ATTACHMENT 8a

Detailed Listing of Changes to DPC-NE-2011-P-A

This attachment provides a detailed list of proposed changes to the topical report DPC-NE-2011P. Changes are listed according to the location in DPC-NE-2011PA. Cited references are listed at the end of this attachment.

10. Figure 1

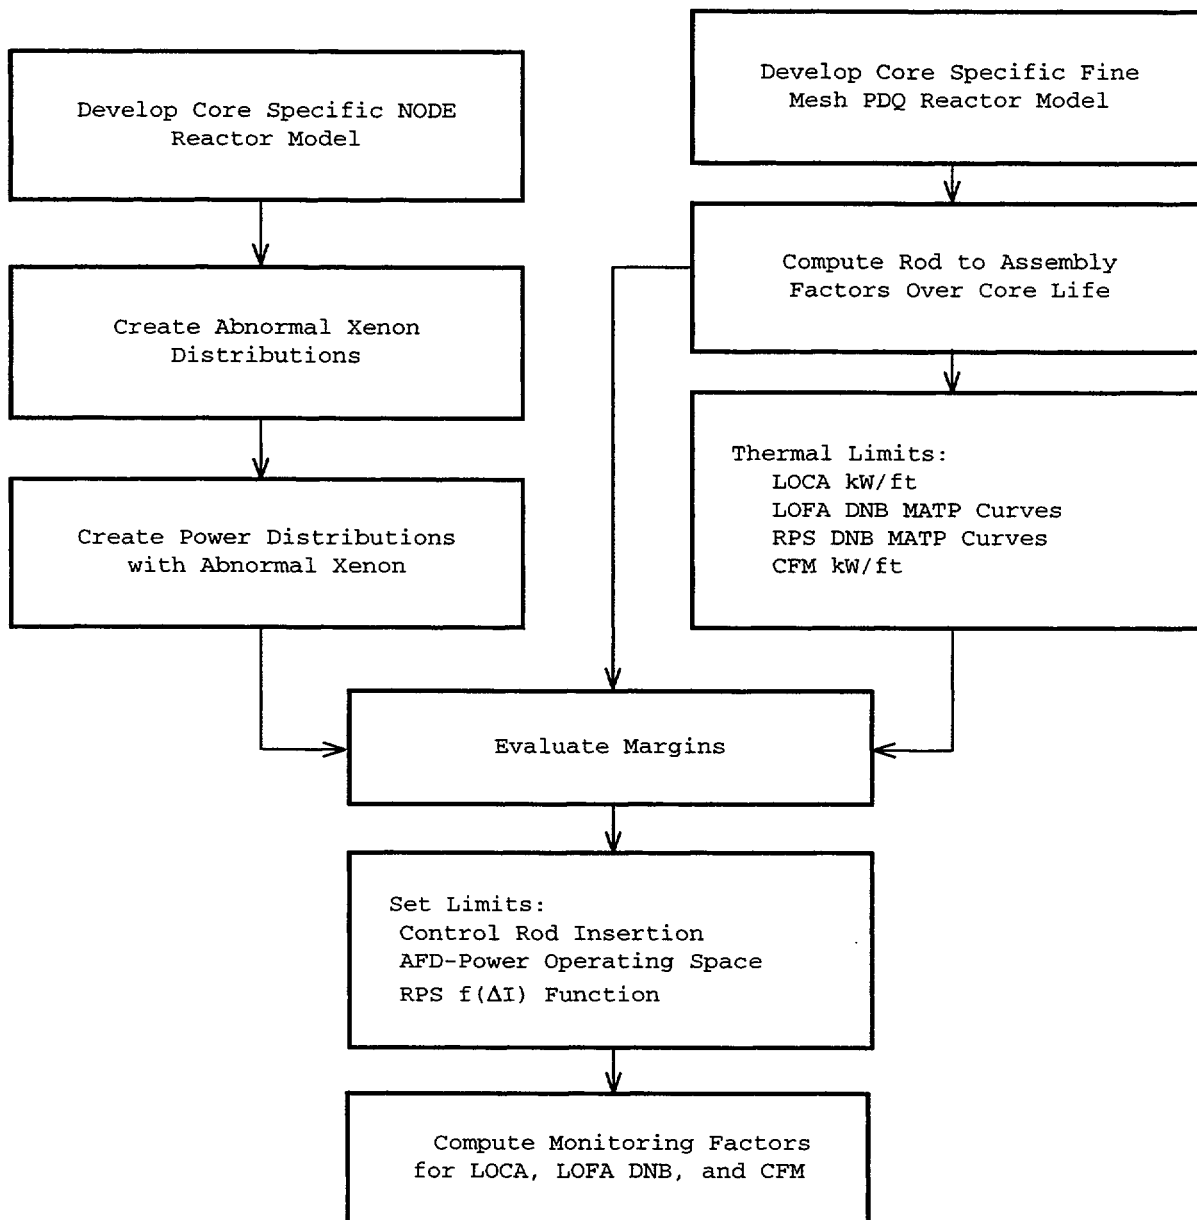
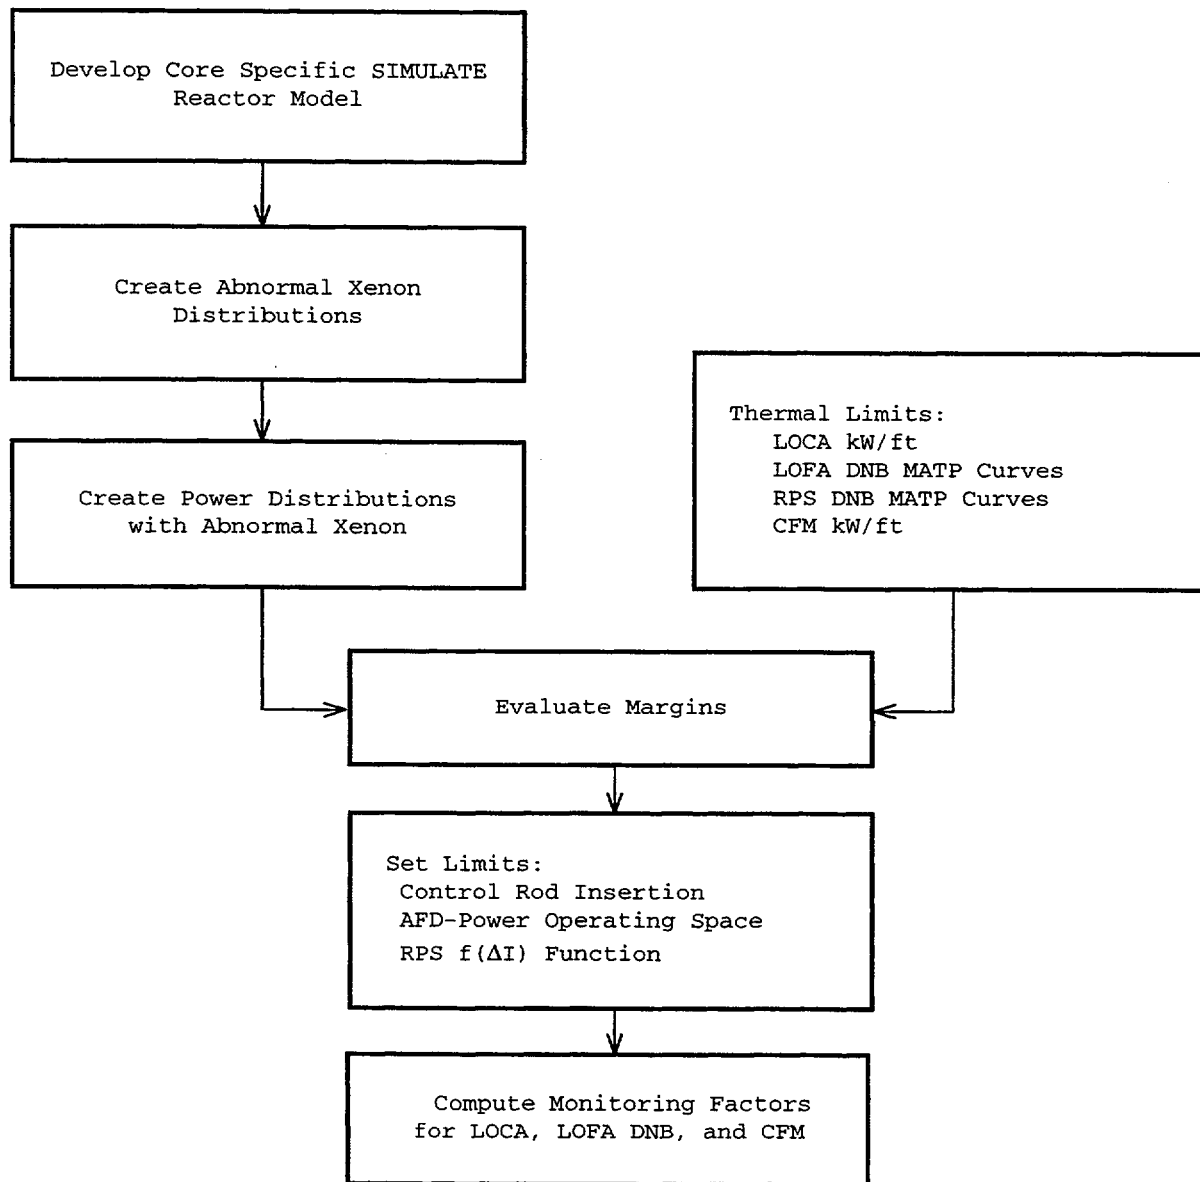
Description: Editorial change to add CFM to the list of computed monitor factors. Added a flow diagram for a SIMULATE based maneuvering analysis to makes the report consistent with current NRC approved methods (Reference 1).
